## Bulletin Topic: Box Hill Compatible Hand Radio Remote

Part No: W005-039

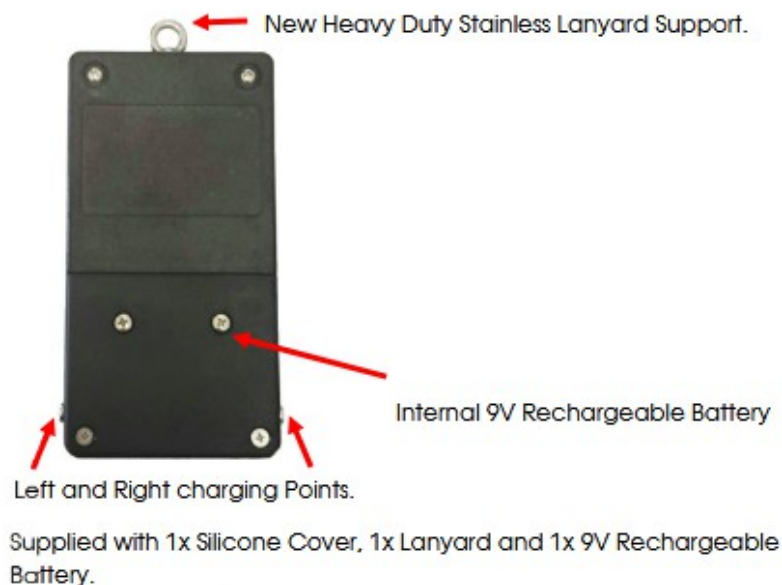
Box Hill uses combinations of red and blue jumpers on various models. Soldering wires or jumpers correctly can be difficult, especially when on site.

When using the new Box Hill Compatible Hand Radio Remote the configuration is very easy. Dipswitch 1(JP1) ON replaces the blue wire. Dipswitch 2(JP2) ON replaces the red wire.
